IEEE 802.3da SPMD TF
TSSI text to adopt.

Peter Jones - Cisco

Figure 148-2—PLCA functions within the Reconciliation Sublayer (RS)

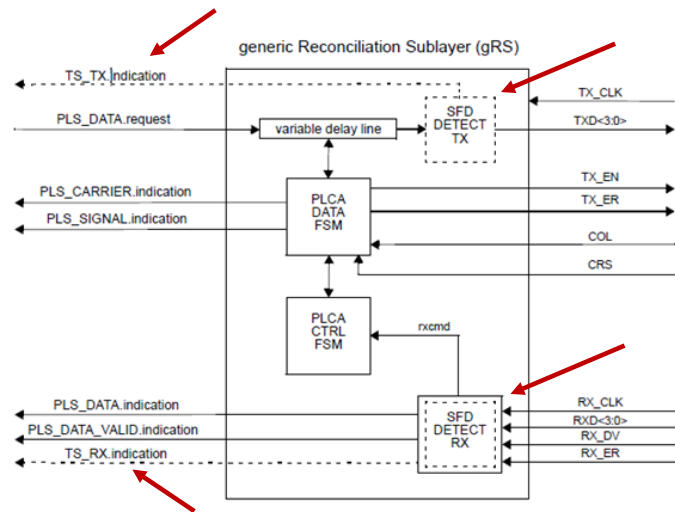
Modify "Figure 148-2--PLCA functions within the Reconciliation Sublayer (RS)" to add *TS_TX.indication*, *TS_RX.indication*, *SFD DETECT TX* and *SFD DETECT RX* as shown in 802.3cg 2019 D2.0 Figure 148-2.

When TSSI is supported, transmit SFD detection occurs after the PLCA variable delay line, as shown in Figure 148-2.

*Clause 90 defines *TS_TX.indication* (90.4.3.1) and *TS_RX.indication* (90.4.3.2). Clause 90 also defines *TS_SFD_Detect_TX* (90.5.1) and *TS_SFD_Detect_RX* (90.5.2), these are shown in Figure 148-2 as *SFD DETECT TX* and *SFD DETECT RX* respectively.*

When TSSI is supported, transmit SFD detection occurs after the PLCA variable delay line, as shown in Figure 148-2.

*Clause 90 defines *TS_TX.indication* (90.4.3.1) and *TS_RX.indication* (90.4.3.2). Clause 90 also defines *TS_SFD_Detect_TX* (90.5.1) and *TS_SFD_Detect_RX* (90.5.2), these are shown in Figure 148-2 as *SFD DETECT TX* and *SFD DETECT RX* respectively.*
